Enclosed is the information I said I would send to you regarding the overflow pipe at Williams Lake. Your Dams and Diversions section has the original file and refer to this as a spillway. The file number is 075-XX05 Williams Lake.

RE: WILLIAMS LAKE

RECORD OF INSPECTION OF DAM

SUBJECT: Inspection of Williams Lake Outlet

New outlet pipe along slope and at downstream end.

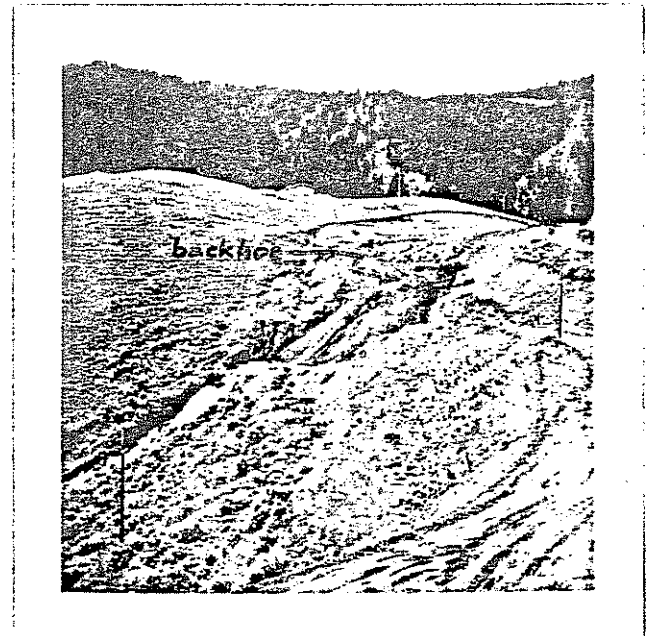
2. Check downstream end of outlet pipe after construction complete to see if pipe leak has stopped.
3. Suggest that resort owner maintain a good trashrack at pipe entrance and provide protection against hazard to people caused by presence of the pipe entrance near a heavily used resort. Several bars are present now to screen out large debris.

One of the three or four places along a 15 foot width of hillside north of the outlet where new seepage is present.

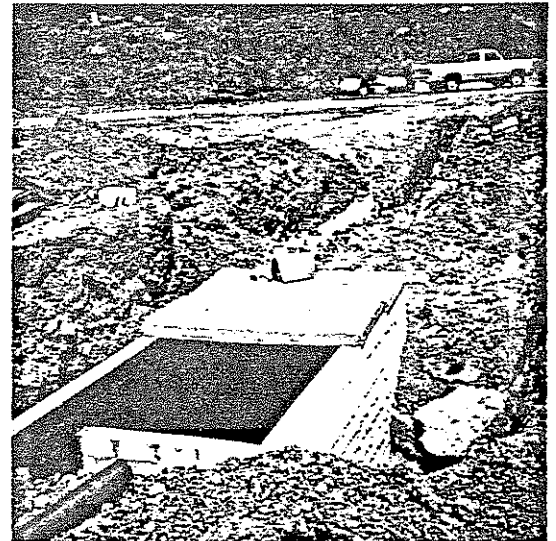
A new seepage area has developed north of the outlet a considerable distance (see map), and this has worried some people in the area who are nervous because of the recent failure of Teton Dam, according to Mr. Heald. He indicated that the seepage began when the unusually high lake level occurred, and he feels it is decreasing now that the lake is starting to drop again. One reason why it is so apparent may be that access roads to the lake criss-cross the hillside west of the lake, and the seepage is running down onto the road. I estimate that the seepage emerges approximately 70 feet below lake level, and approximately 1/2 mile from the lake. It is running clear at an estimated 10 GPM±, and emerges from several areas in a 15 foot width along the mountainside. Because of the distance the seepage must travel and its small quantity, I am not concerned about it; however, it may be advisable to check it again to insure that it does not increase or to see if it stops when the lake level drops.

1. Check seepage north of outlet later this summer to see if any change has occurred.
